APPLICATION FOR CERTIFICATE OF APPROPRIATENESS HISTORIC CONSERVATION BOARD PUBLIC HEARING STAFF REPORT

APPLICATION #: COA2019008
APPLICANT: New Republic Street
OWNER: Molly Reckman
ADDRESS: **227 Magnolia Street**
PARCELS: 081-0002-0241, 240
ZONING: CC-A
OVERLAYS: Over-the-Rhine Historic District
COMMUNITY: Over-the-Rhine
REPORT DATE: March 13, 2019
HEARING DATE: March 25, 2019
STAFF REVIEW: Beth Johnson, Urban Conservator

**APPLICATION FOR
ZONING RELIEF AND
CERTIFICATE OF APPROPRIATENESS
HISTORIC CONSERVATION BOARD PUBLIC HEARING
STAFF REPORT**

APPLICATION #: ZH20190017/COA2019007
APPLICANT: New Republic Architecture
OWNER: OTR Community Council
ADDRESS: **1505-1507 Vine Street**
PARCELS: 081-0004-0072; 081-0004-0071;
ZONING: CC-P
OVERLAYS: Over the Rhine Historic District
COMMUNITY: Over the Rhine
REPORT DATE: March 11, 2018
HEARING DATE: March 25, 2018
STAFF REVIEW: Beth Johnson, Urban Conservator

PARTIAL NORTH ELEVATION
SCALE: 1/4" = 1'-0"

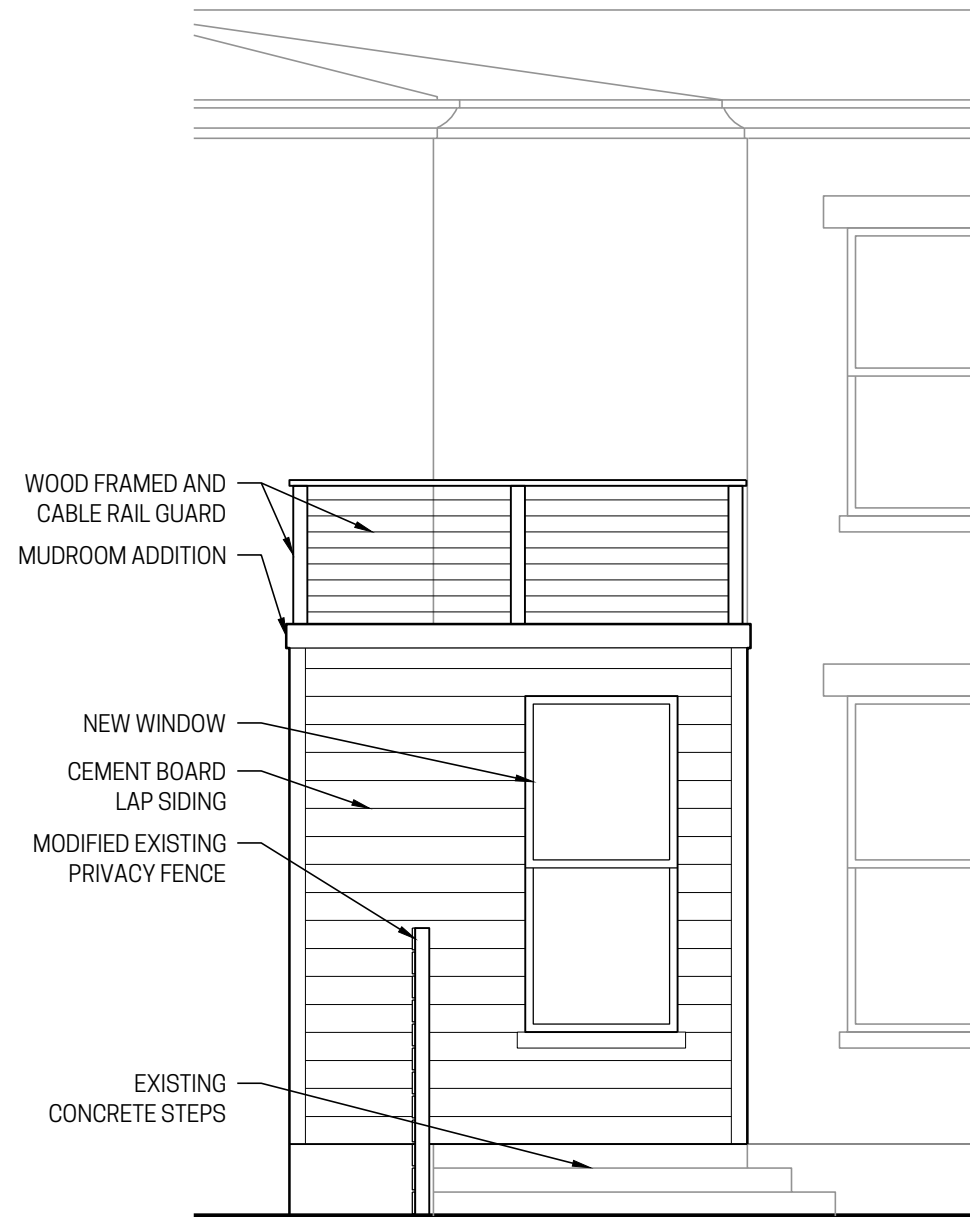
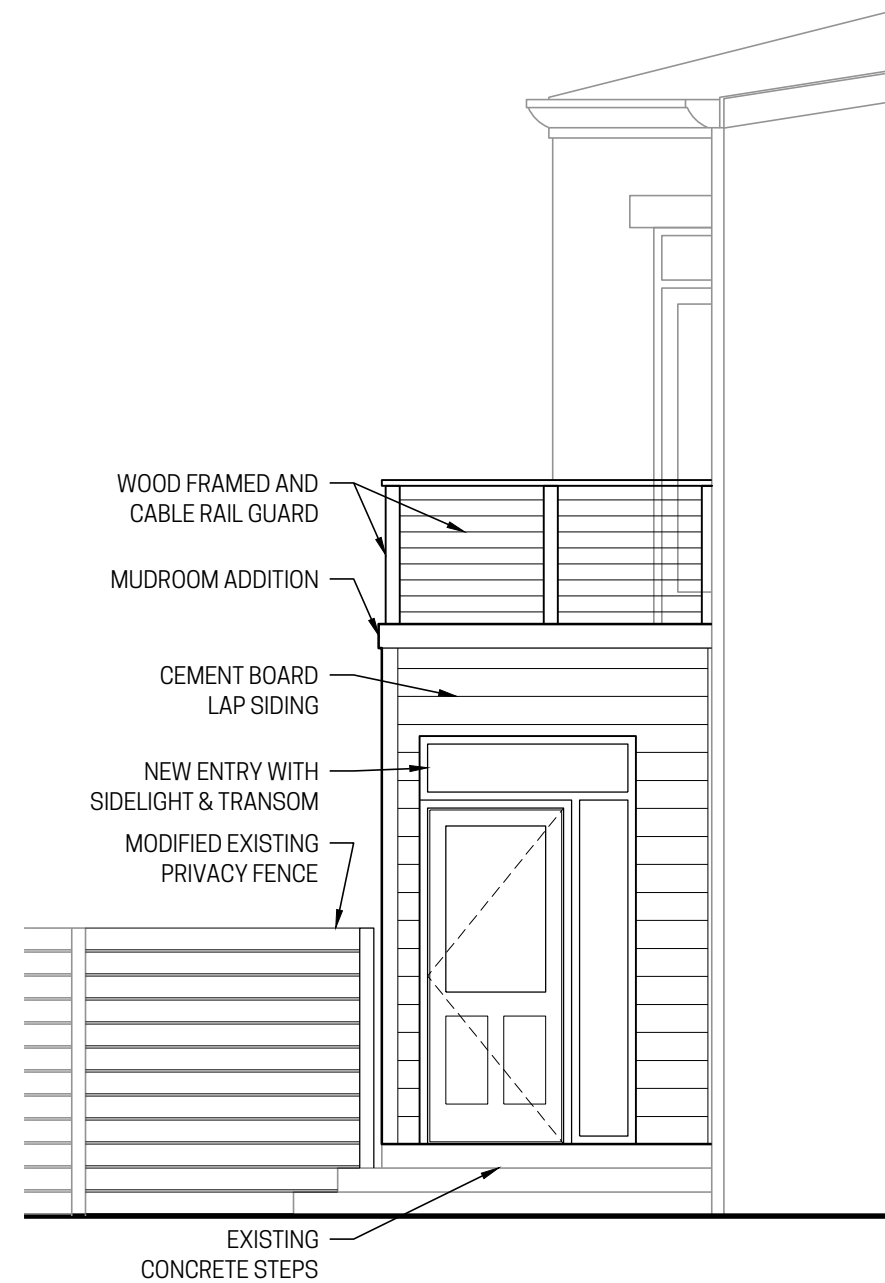
The addition of the mud room is small 1 story addition with a roof balcony for access from the second story. The addition will be a cement board lap siding frame addition which is appropriate for a small addition as historically there were small rear and side frame additions throughout OTR. The different use of materials is compatible but also differentiates the building from the original building.

The addition is setback to the same line where the existing privacy fence is and will not overpower the original building.

1. Building permits must be issued within 2 years of or the COA will expire.
2. A plat consolidation shall be recorded before building permits are issued.
3. The cement board shall be smooth sided.

1 Front Elevation
A04 Scale: 3/16" = 1'-0"

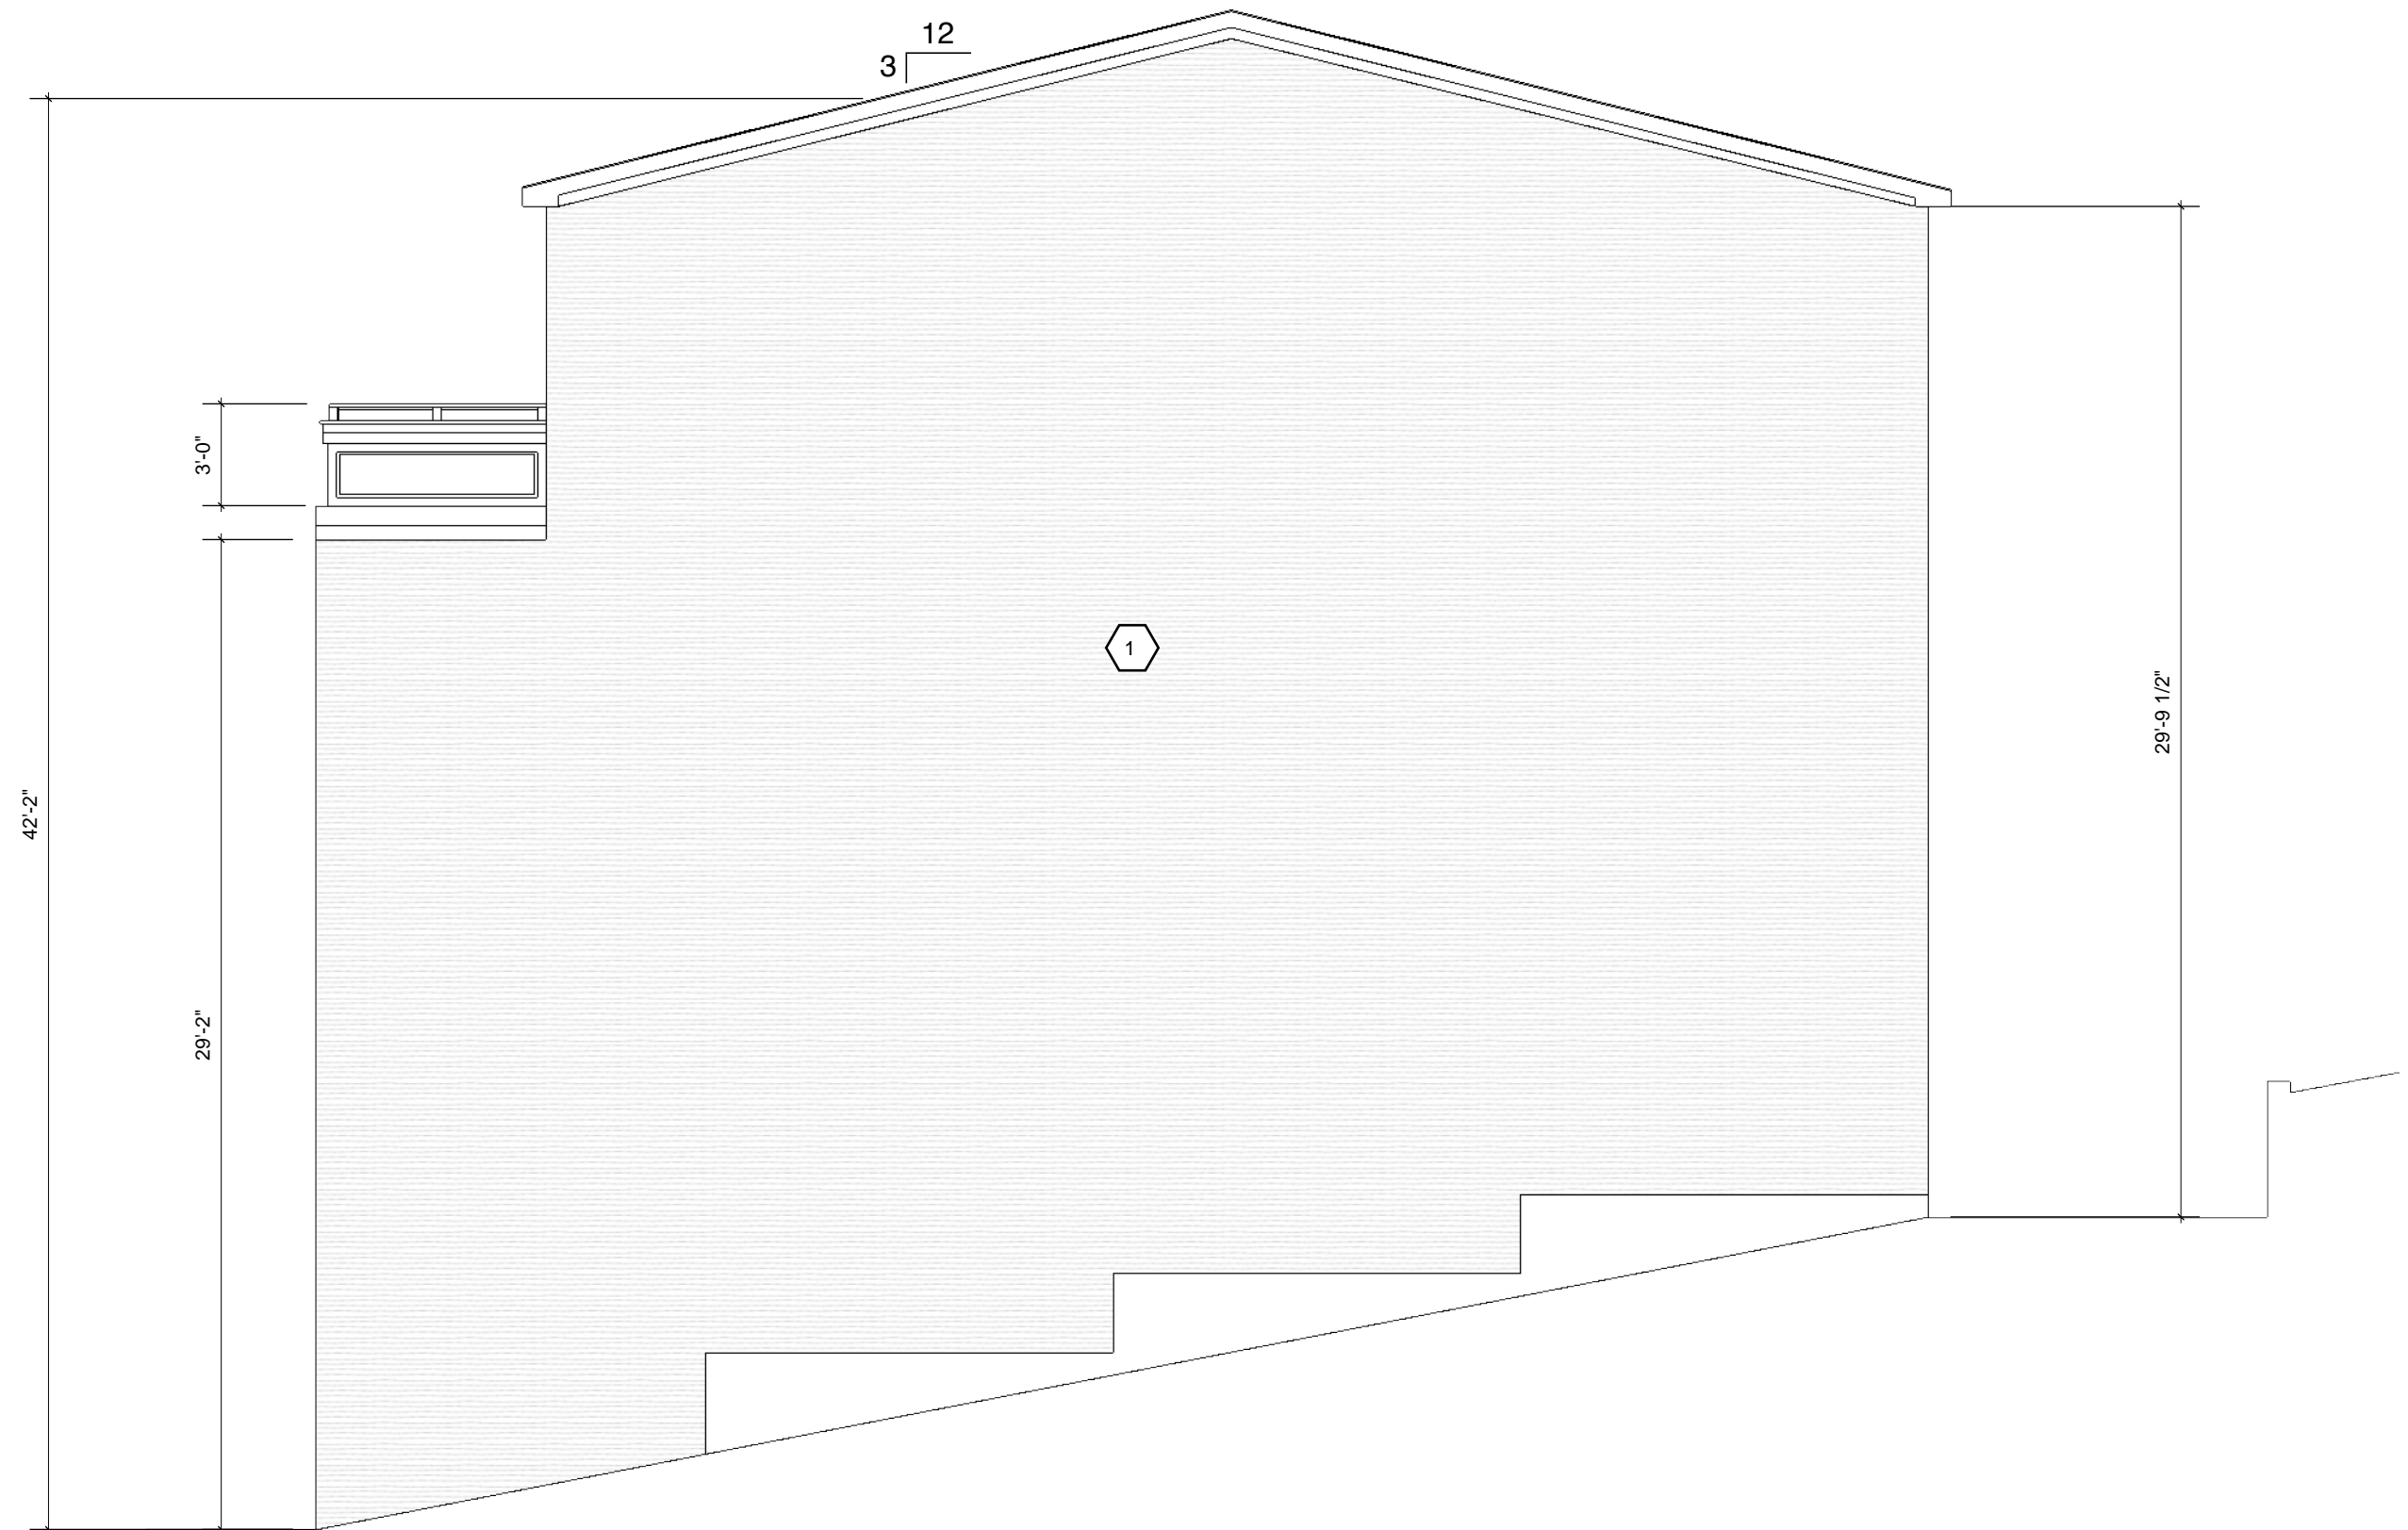
A simple solution to keep the same design of the façade and to meet the restrictions of the deed restriction could be to design a flat/shed roof to remove the pitch which is what is encroaching onto the 40 feet maximum height. 40 feet is approximately at the height of the cornice of the third level. It is listed on the submitted drawings as 39 ft. 2 in. This would still allow for approximately 8 foot ceiling heights at the third level; however the elevator shown might not be able to be incorporated into the third floor except to allow for overrun from the second floor.

1. DOTE approves the curb cuts and access to the property.
2. Hardi-board will be smooth, not wood grained.
3. Facades proposed as brick are not approved for any Engineered Brick. Final specifics on the proposed brick will be provided to the Urban Conservator with the building permit submission.
4. An accurate site plan shall be submitted with the building permits showing the correct footprint of the building at the first floor level and all stormwater collection adjusted accordingly.
5. The building permits must be issued within two years of the decision date or the Certificate of Appropriateness shall expire.
